Horizon

Lee 5 Honeysuckle

Design Report

This design report illustrates the design process with feedback and commentary from the panel.

2.5 State Design Review
Panel Meeting 01

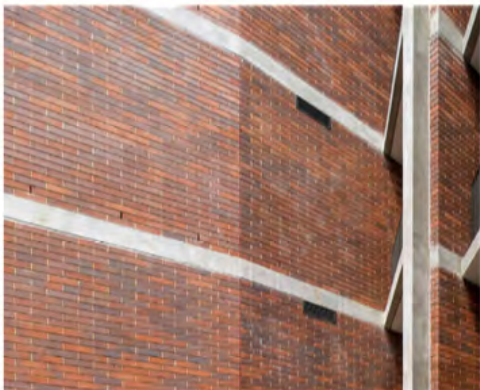
The panel supported the proposed setbacks to align with other developments in the precinct. The building bulk is suitably porous. Some western height uplift is supported as mentioned above. The panel commented on further articulation to the roof profile. The panel strongly supported provision of common roof space over the central building.

ARCHITECTURAL CHARACTER + MATERIALITY

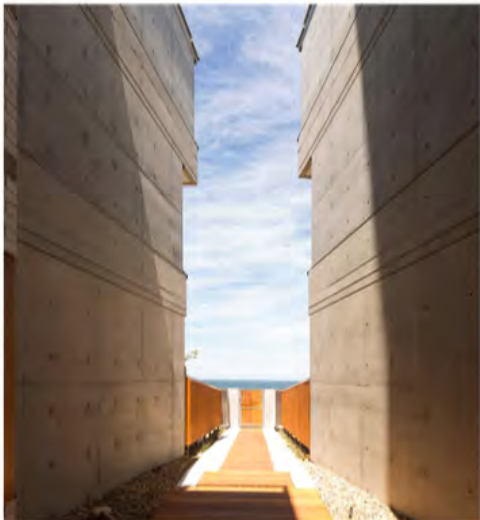
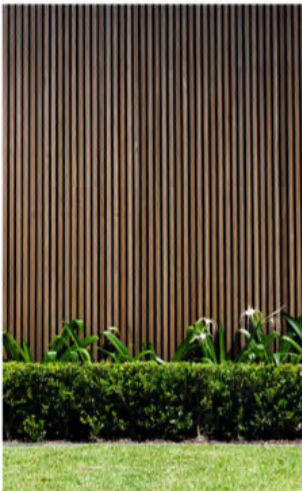
The panel commended the robust, well-mannered architectural character of the scheme. The elegant material palette was noted; panelists look forward to further resolution of the facades as the project develops. The weight of the north façade was supported, however brick masses on the south façade seemed unresolved. East and west facades are significant and need further design. Given the generous balconies, the panel suggested that partly solid balustrades would reduce reflectivity, improve privacy and enhance the outdoor room quality of these spaces. Sharp angular corners of balconies could also be resolved. Risks for the seaside location were discussed; the panel expressed concern that concrete elements are constructed by skilled contractors and to a high class finish. Wind will be an issue post occupation and should be carefully considered in the design of all façades.

3.2 Public Domain

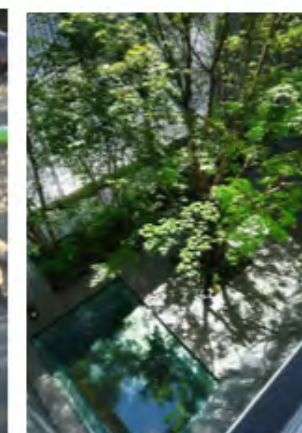
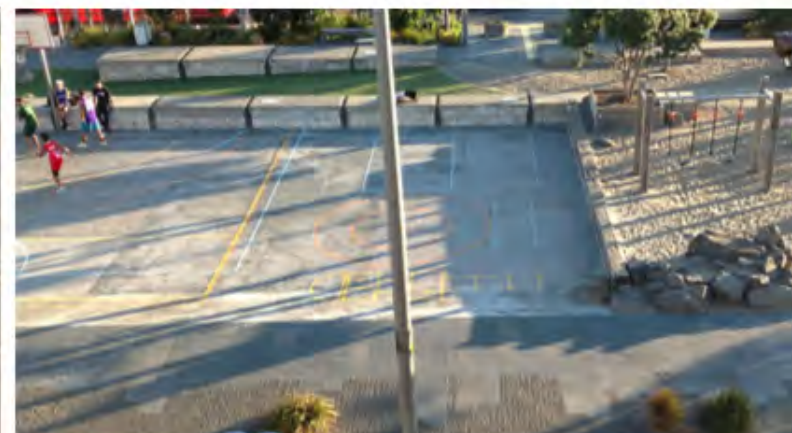
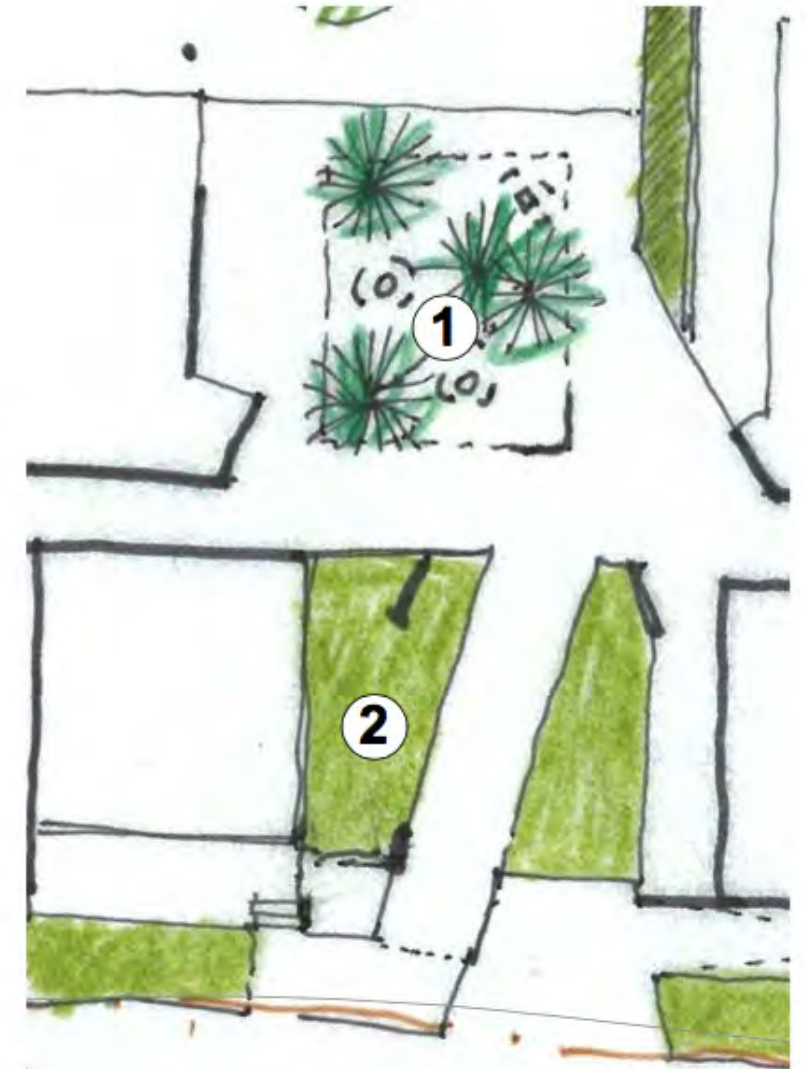
The panel were generally supportive of the emerging landscape plan. Raised planting fronting the northern foreshore provides intimate seating alcoves and a dynamic edge condition. Interior courtyards and entry gardens are an asset to the common areas.

The panel supported common areas at roof level and acknowledged that the proposed central rooftop common area provides good resident amenity. The covered space could be improved to accommodate family functions and a kitchenette.

3.4 Entry Hierarchy and Circulation

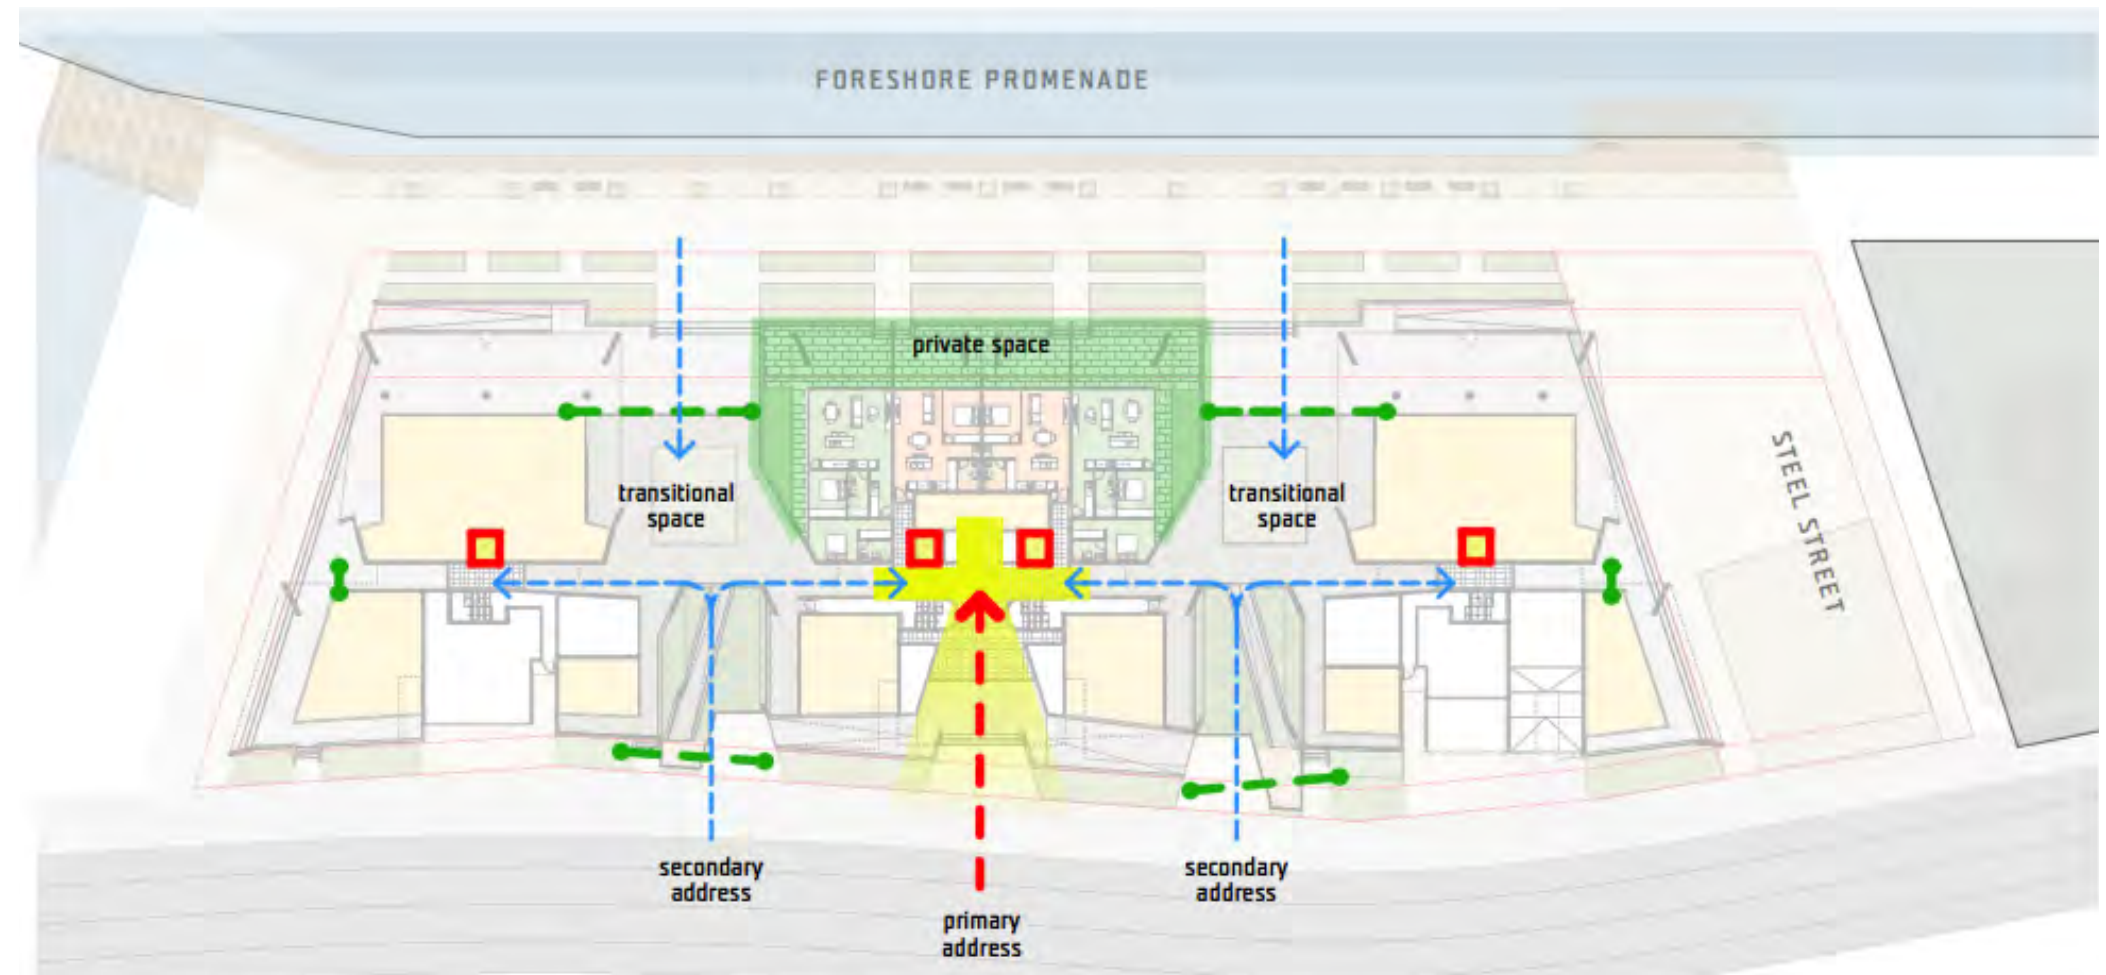
The panel noted the proposed scheme continues to navigate the dual frontages to Honeysuckle Drive and to foreshore promenade. The panel supported the revised entry hierarchy. A legible main entry has been established from Honeysuckle Drive through the central building, and secondary front entries are provided in the eastern and western buildings.

On the ground floor, the through-site access from the park (east) to the creek (west) is a successful method of organizing the three buildings. The interior courtyards enhance this connection

3.6 Additional Height

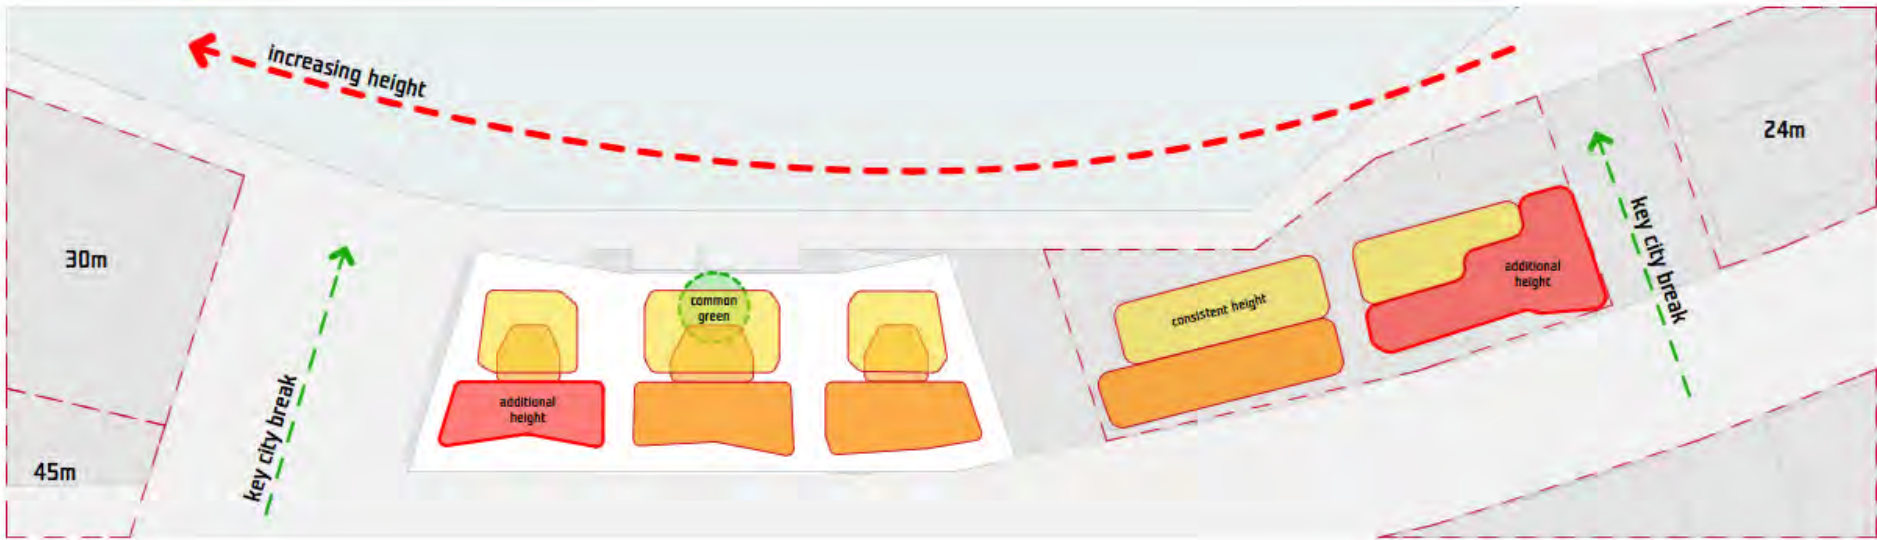
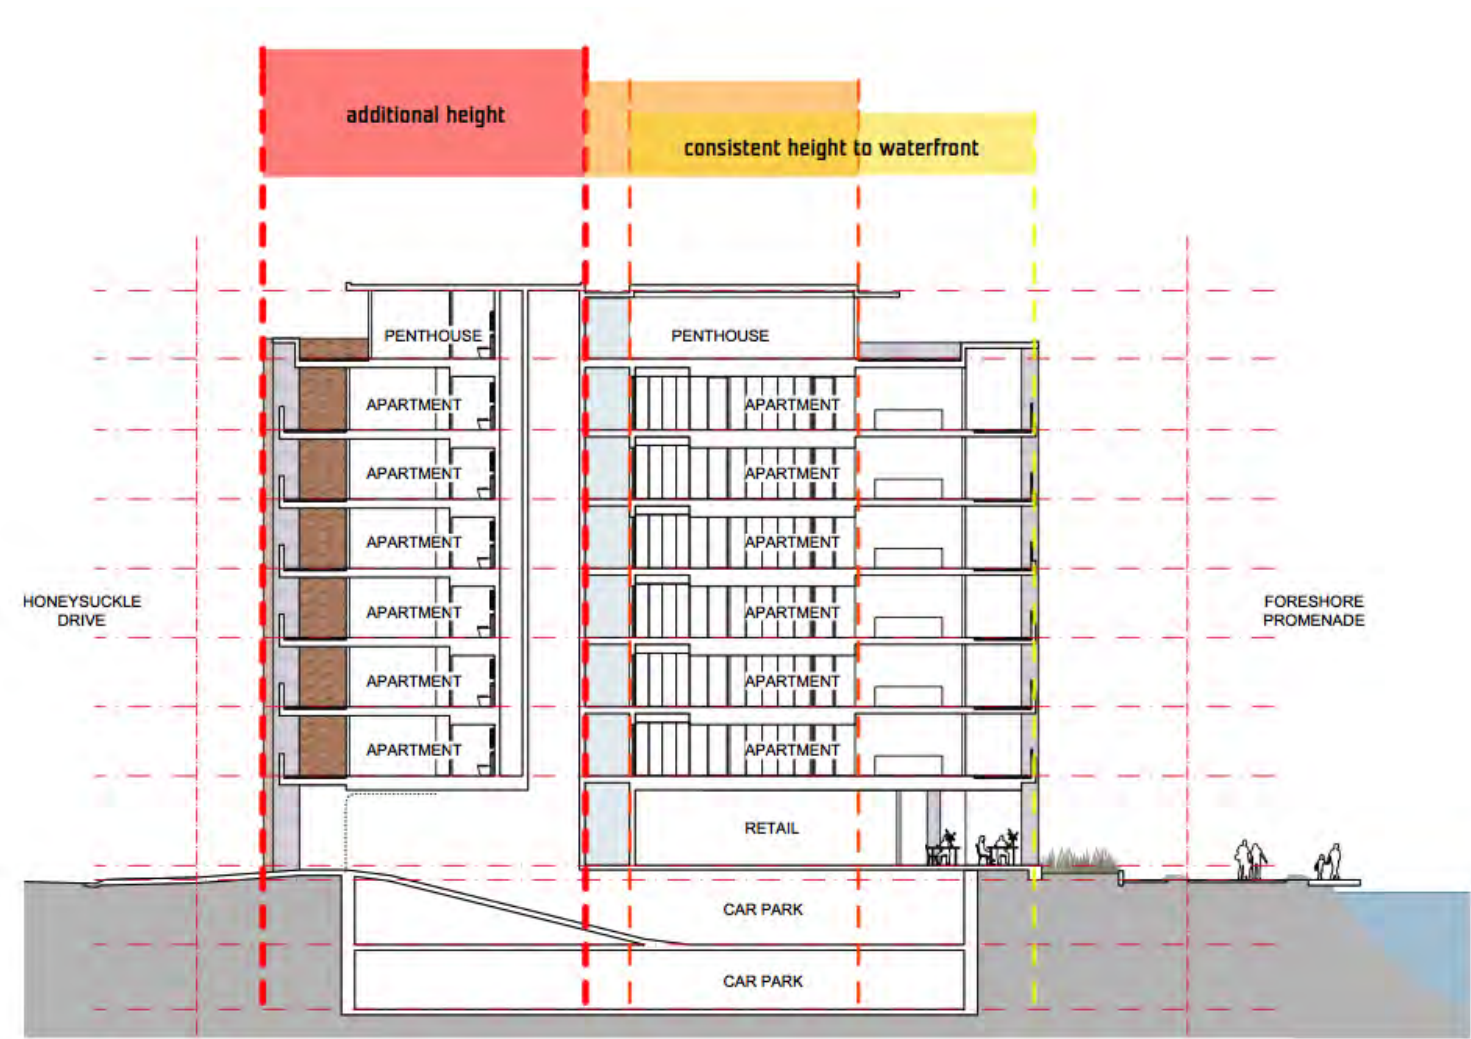
At SDRP 1, the panel supported investigation of increased height to the westernmost building of Lee 5. Redistribution of height and floor area could afford improved communal open space at roof level and better respond to the unique urban design context of the site and its adjacency to future high-density development proposed to the west. The panel supported the team in exploring increased height where impacts to neighbouring buildings and public space can be demonstrated to be negligible.

3.8 Facade Materials

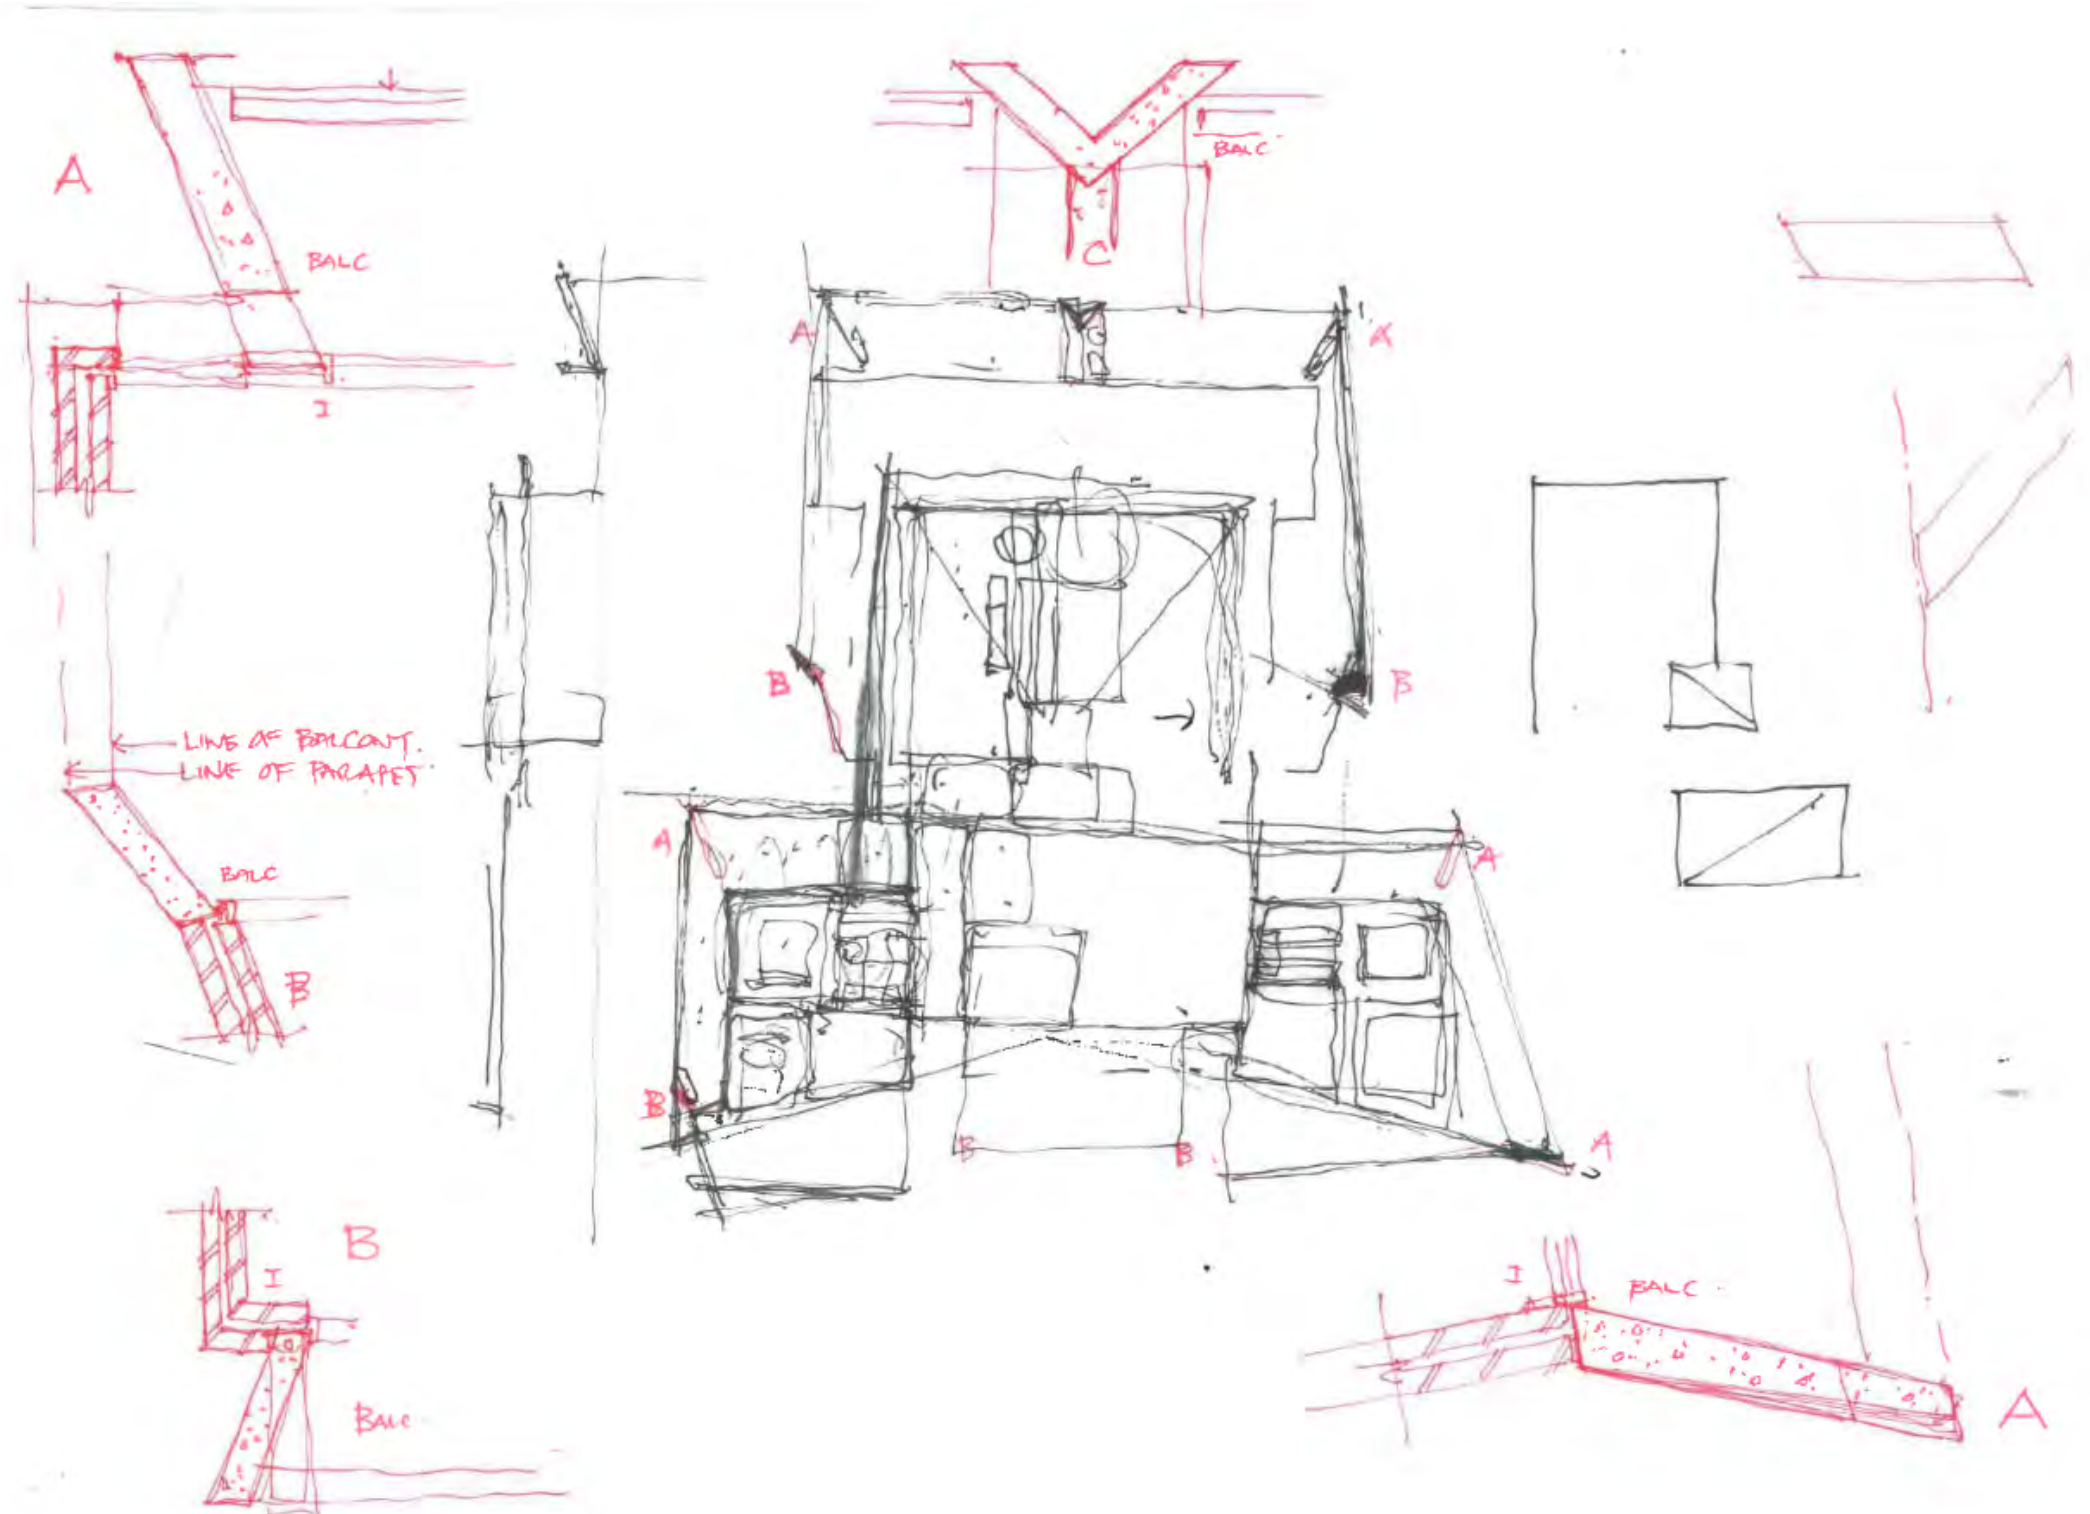
The panel noted that the architectural resolution continues to develop. The articulated concrete structure and subsequent layering of brick and block materials was supported. The design detailing and material resolution of this scheme are significant to its success and a commitment to delivering a high construction standard must be maintained throughout the life of the project.
